Subject: Johnston County - Drawings Showing Phase 4A - Cell 3

**JOHNSTON COUNTY C&D LANDFILL
 AREA 2
 PERMIT DRAWINGS**

**Re: Johnston County MSW Landfill - Phase 4A - Cell 3 (Permit No. 51-03)
Permit Amendment Application
Response to Review Comments and Additional Changes**

Re: Application for Permit to Construct Phase 4A, Cell 3, and Review of Closure/Post-Closure Plan for the C&D unit, in accordance with .0547
Johnston County MSW and C&D Landfill
Permit No. 51-03
Johnston County, Doc ID 6031

DESIGNED BY:	P.K.S.	DRAWN BY:	J.A.L.
CHECKED BY:		PROJECT NO.:	JOHN-02
SCALE:	AS SHOWN	DATE:	OCT. 2005
FILE NAME:	JOHN020005A		
SHEET NO.	3	DRAWING NO.	S2

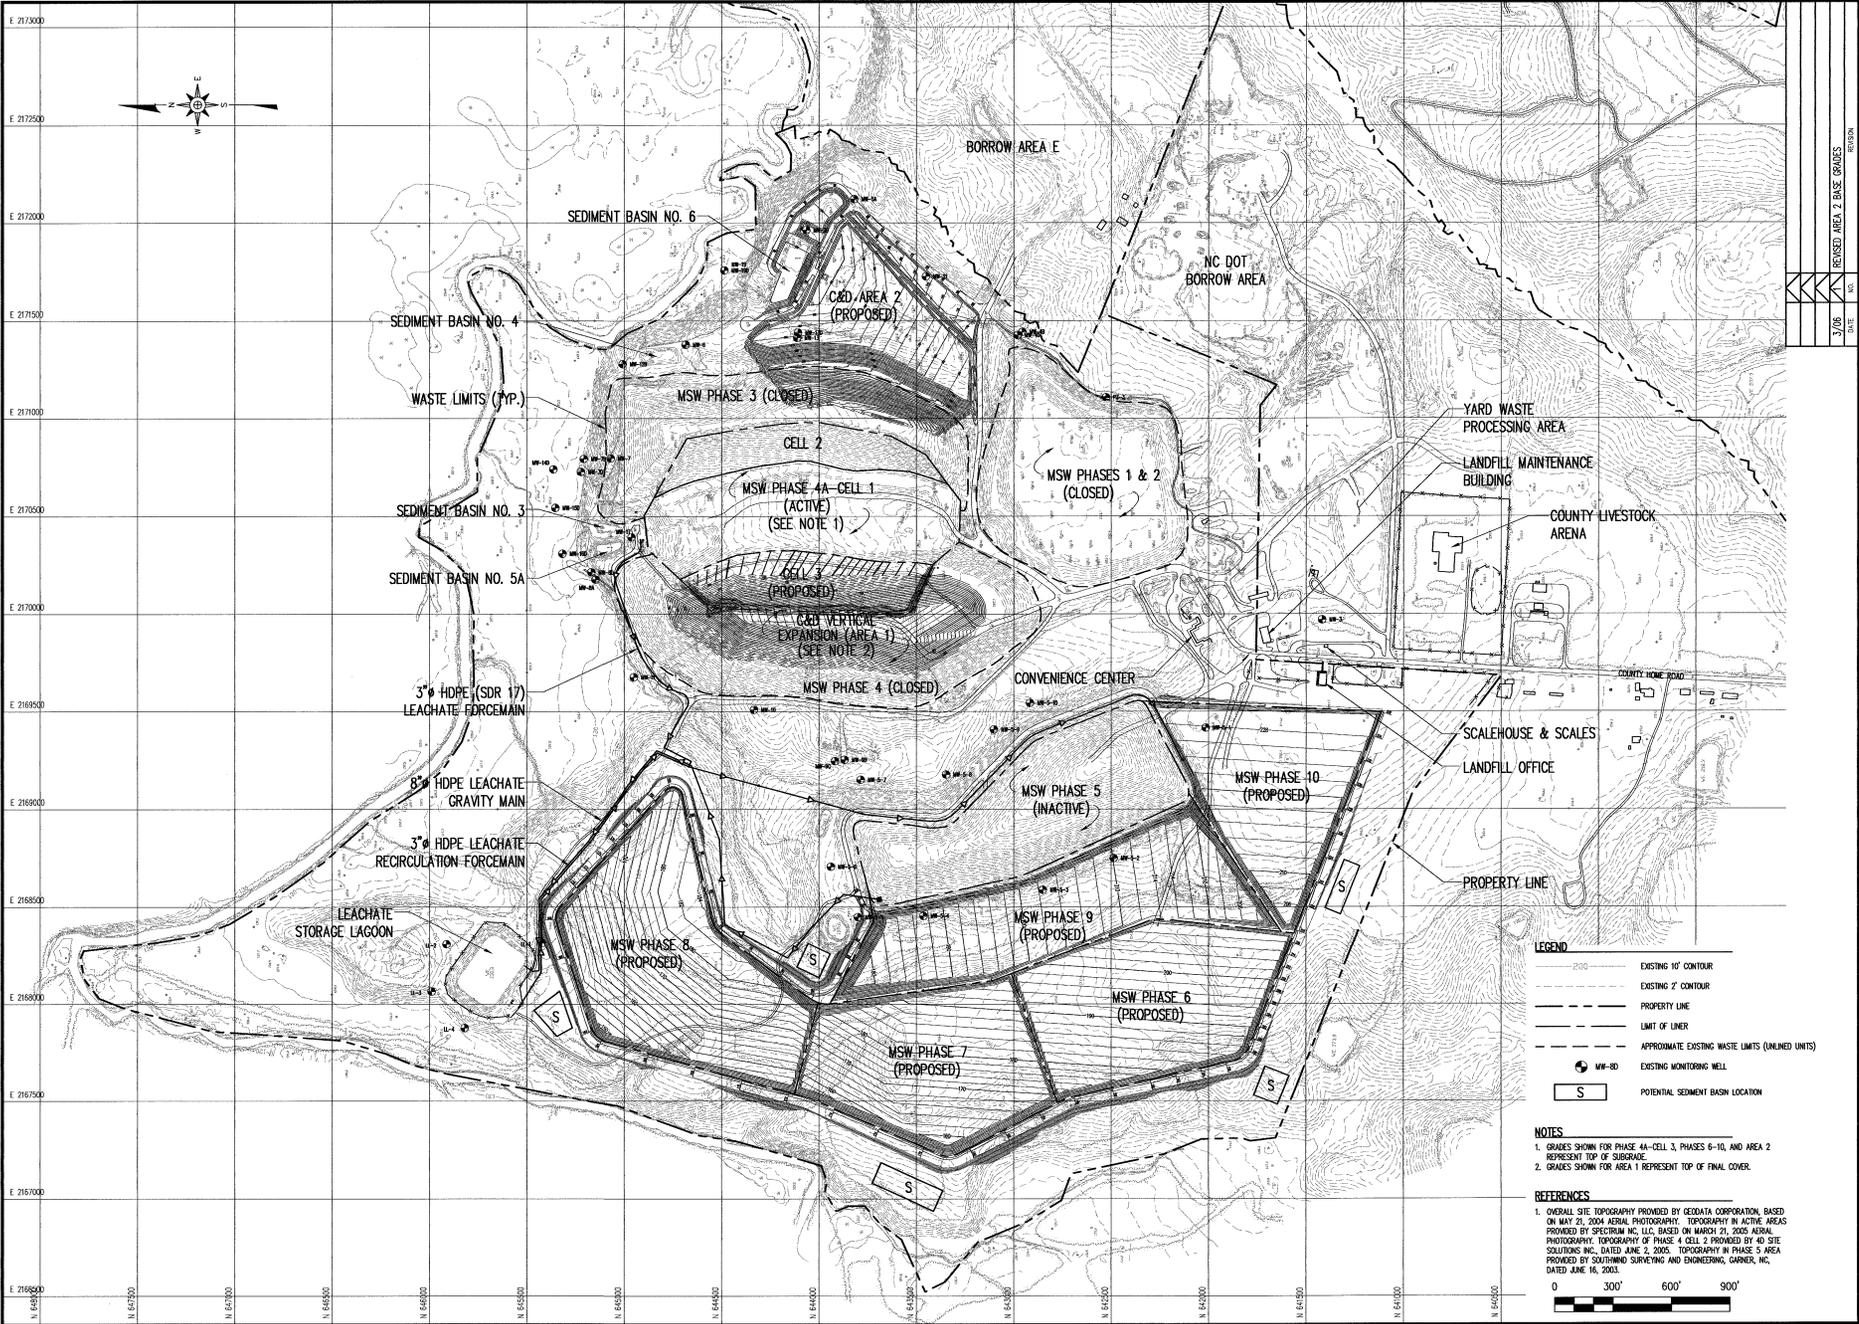
Per our conversation, attached are drawings referenced in the currently approved Facility Plan that show Cell 3. The whole set was too large to email. I'll put on a CD and send separately.

DRAWING TITLE	
DESIGNED BY: PK.S.	DRAWN BY: C.T.J.
CHECKED BY: JOHN-22	PROJECT NO.:
SCALE: AS SHOWN	DATE: OCT 2000
FILE NAME: JOHN-00089	DRAWING NO.:
SHEET NO. 24	P2

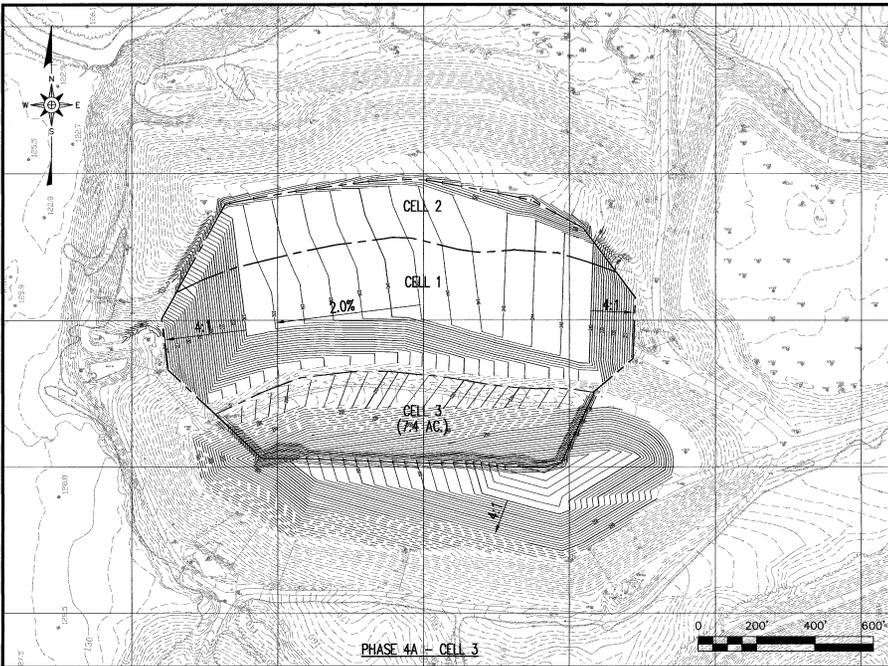
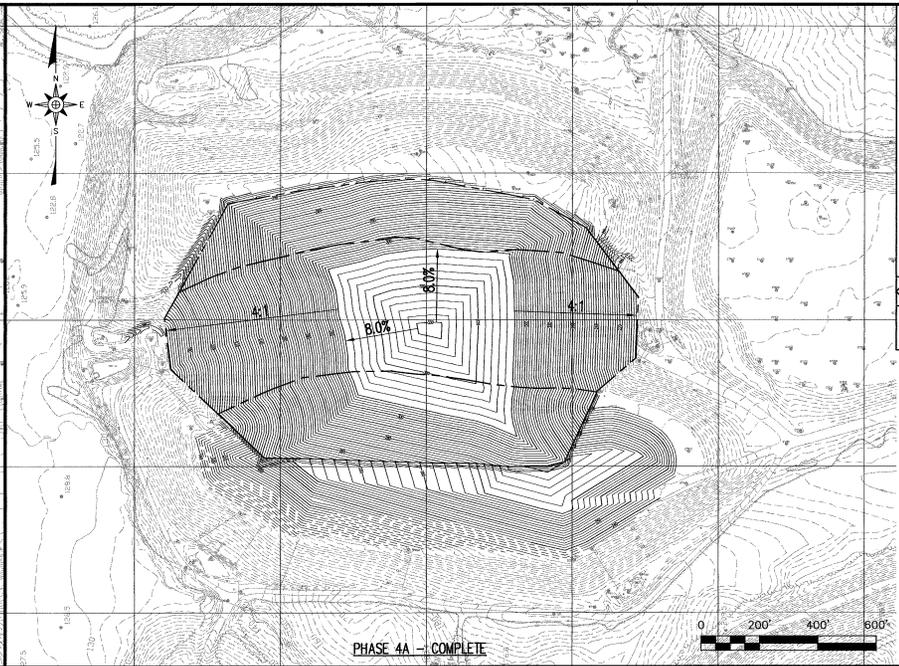
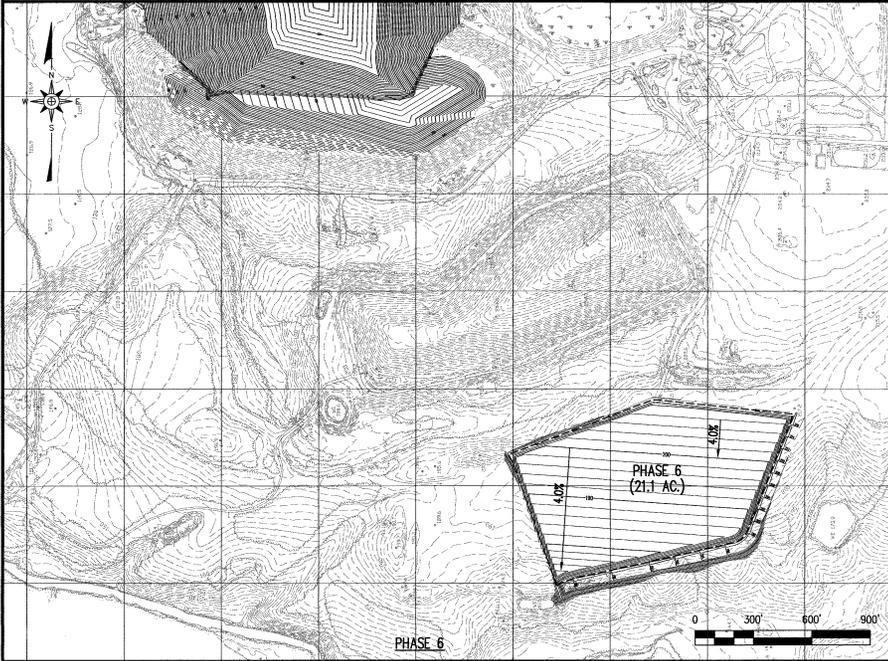
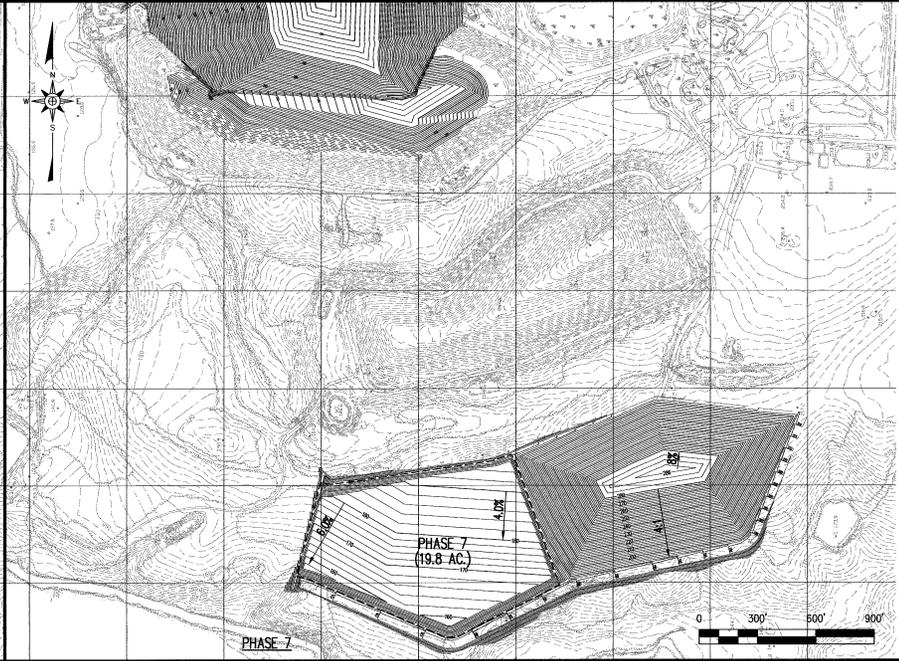
14. *Please include a drawing that shows all future phases, as was in the March 2006 drawings.*

Drawings P1 through P4 have been added to reflect future development. Drawings P1 through P3 show the phasing of MSW landfill units and Drawing P4 shows the phasing of C&D landfill units.
